CHANGE ORDER NO.: 1

Owner: City of Breckenridge
Engineer: e-HT
Contractor: Raydon
Project: Phase III Paving Improvements
Contract Name: Phase III Paving Improvements
Date Issued: 11/12/2025

Owner's Project No.: N/A
Engineer's Project No.: 5580-42
Contractor's Project No.: N/A

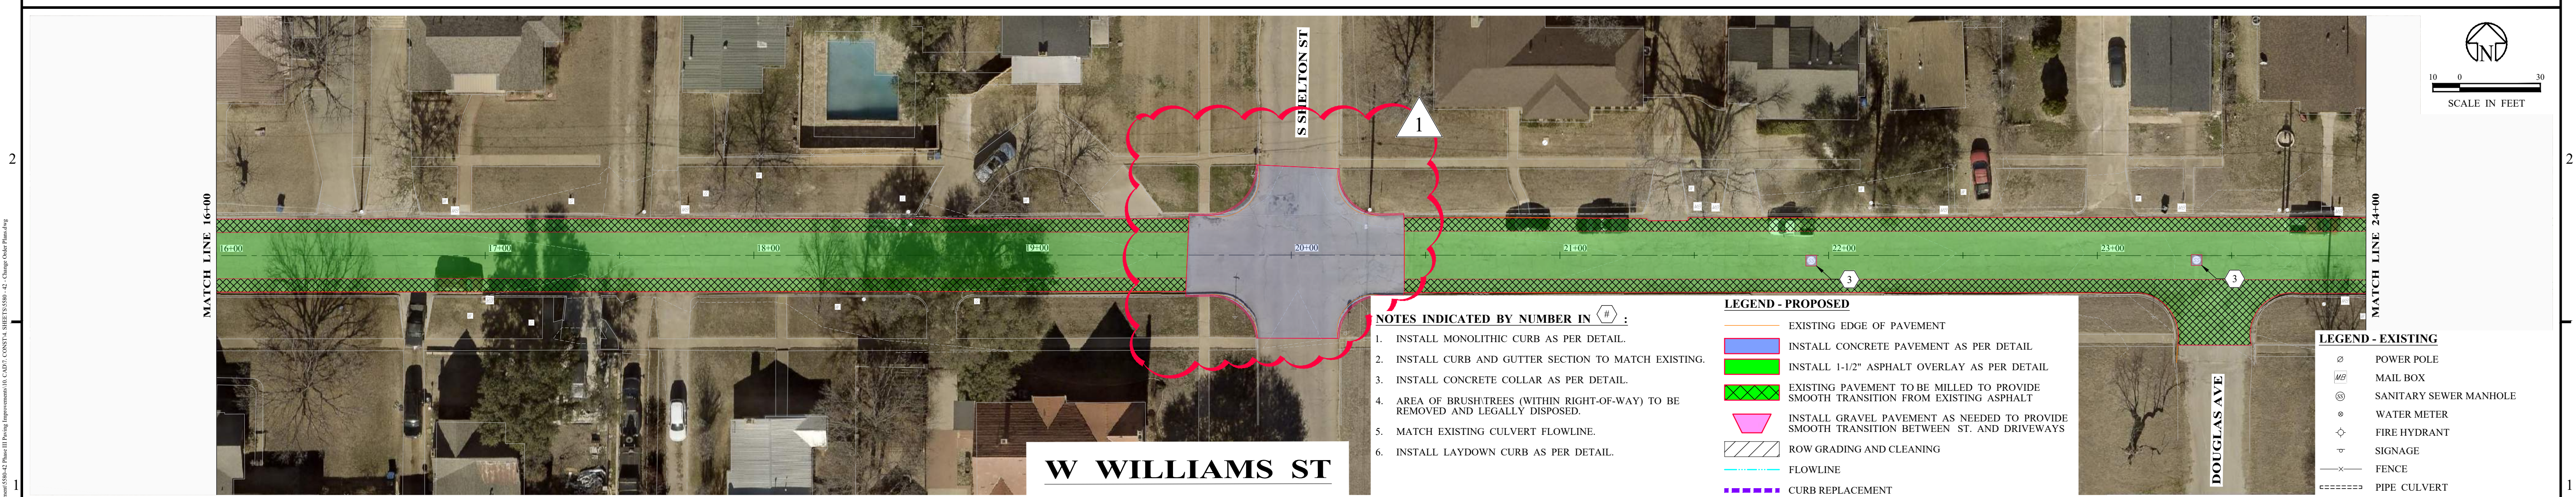
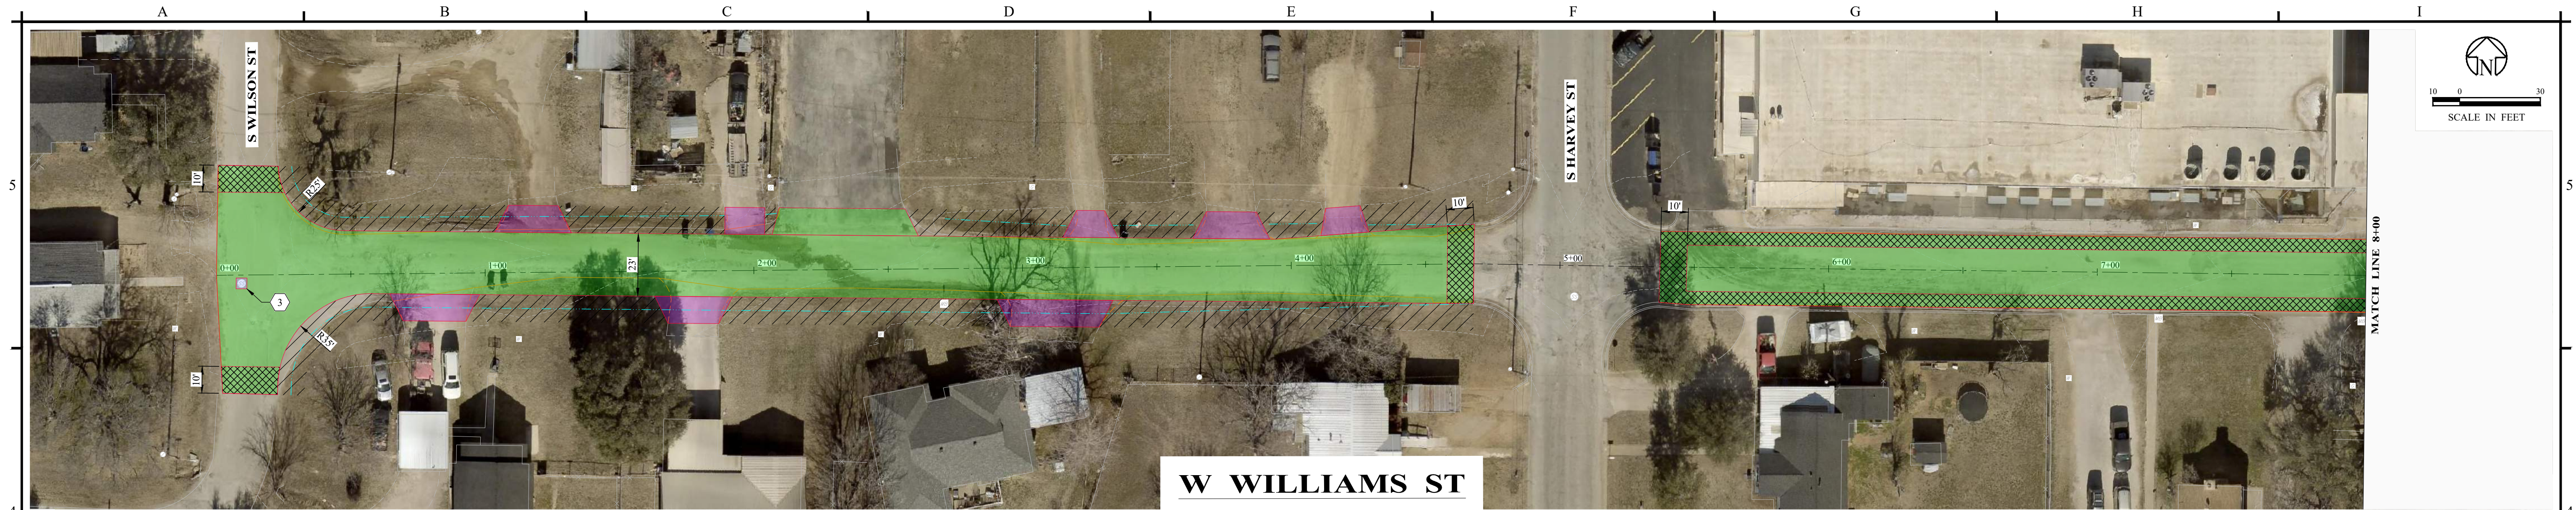
- Quantity adjustment to install monolithic concrete pavement and curb at the intersection of W. Williams Street and S. Shelton Street.
- Repair damaged sections of monolithic curb along S. Oakwood Street.
- Roadway rehabilitation of approx. 2,295 LF of Northglen Street; including but not limited to asphalt pre-lay, asphalt overlay, and ditch grading
- Replace decrepit, shallow water line below new concrete pavement on W. 2nd and N. Miller.

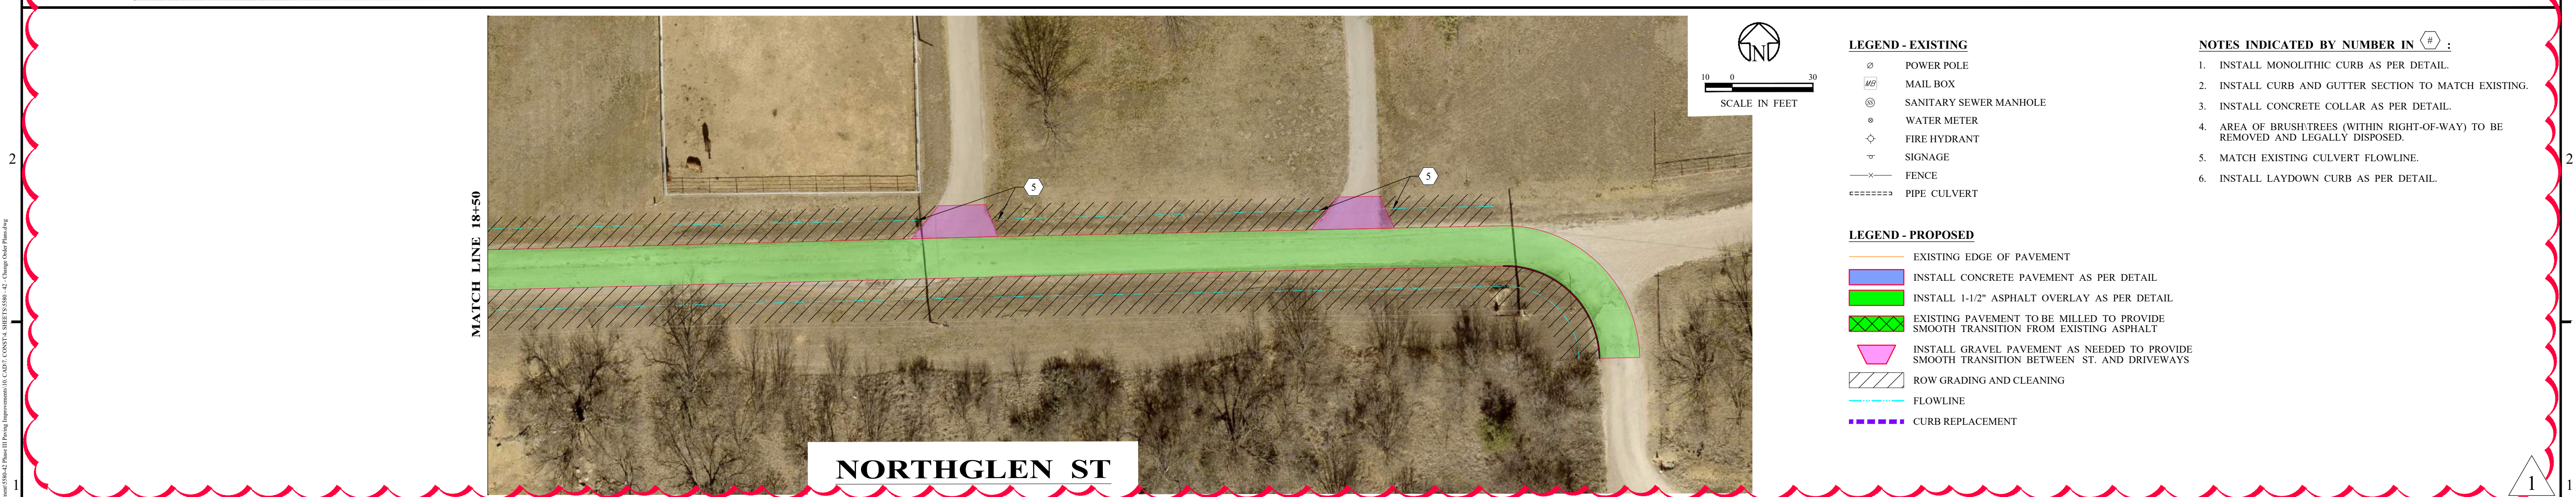
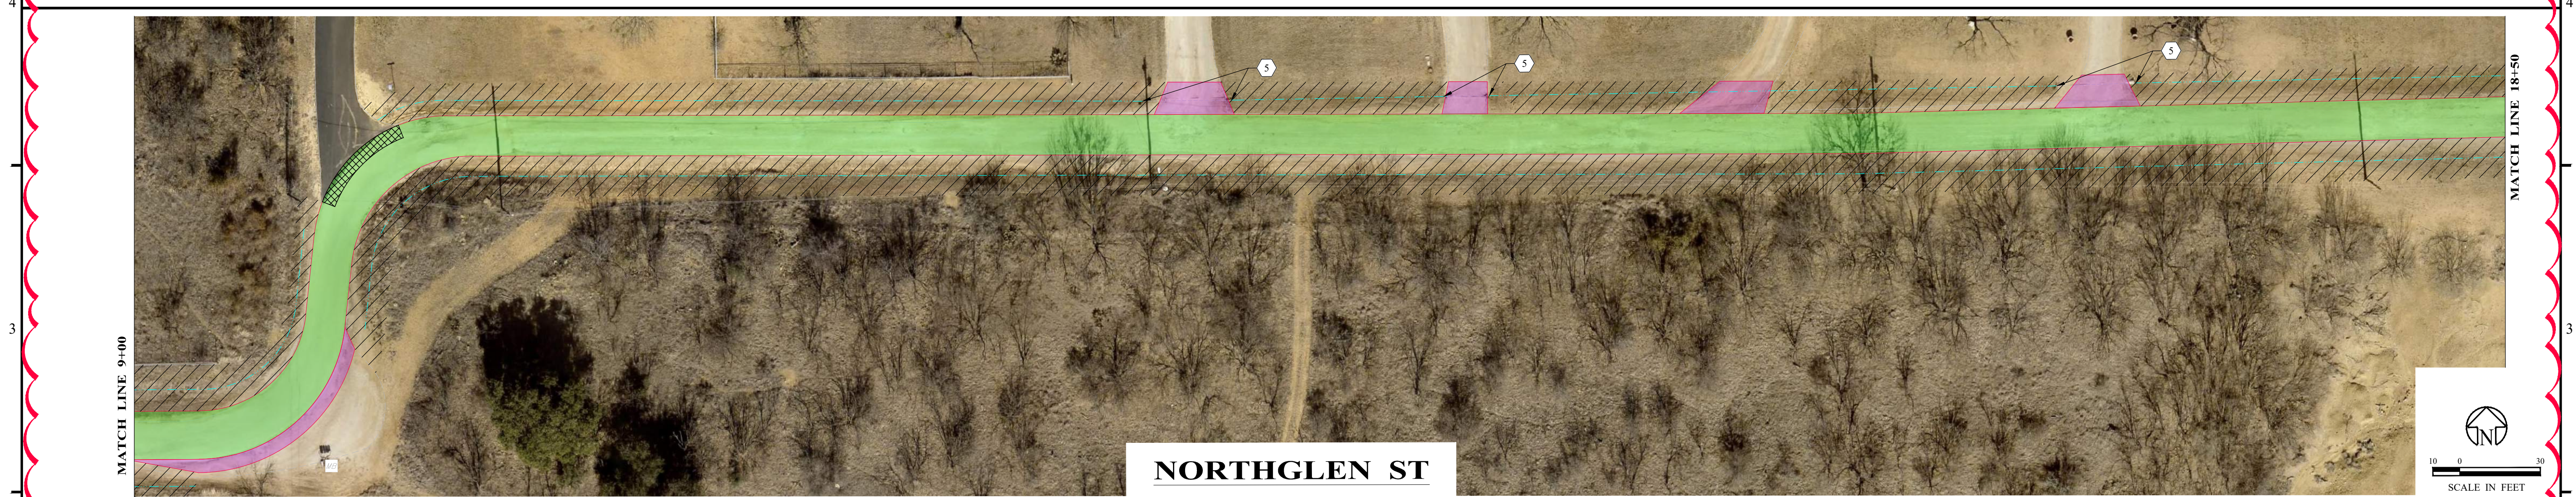
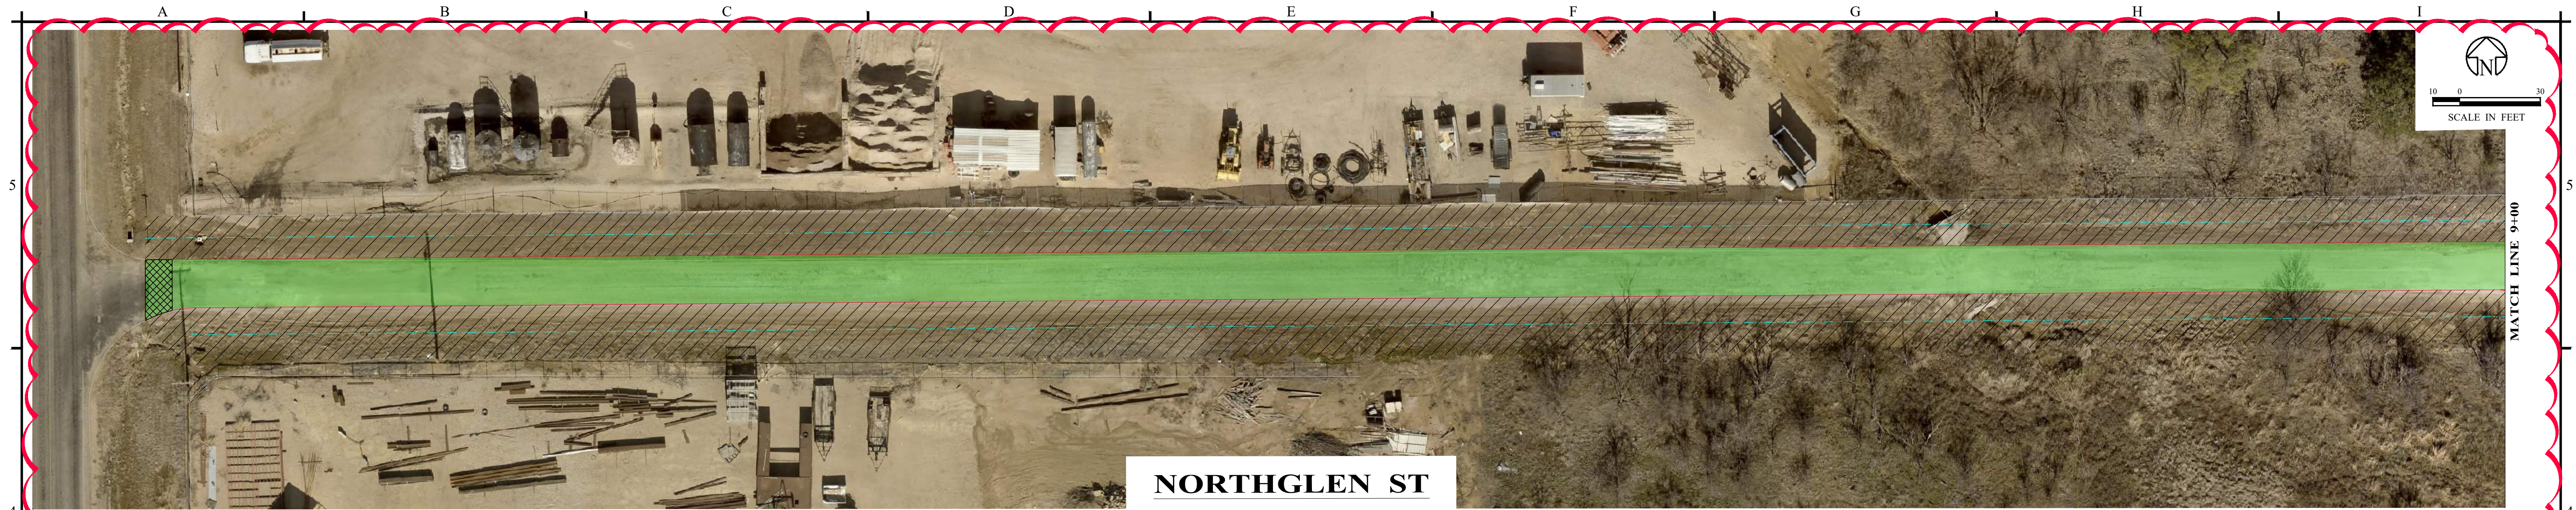
CHANGE ORDER 1: SOUTH OAKWOOD

INSTALL DOWELED CURB ON EXISTING CONCRETE PAVEMENT. ADDITIONAL 148 LF @ \$24.00/LF = \$3,552.00
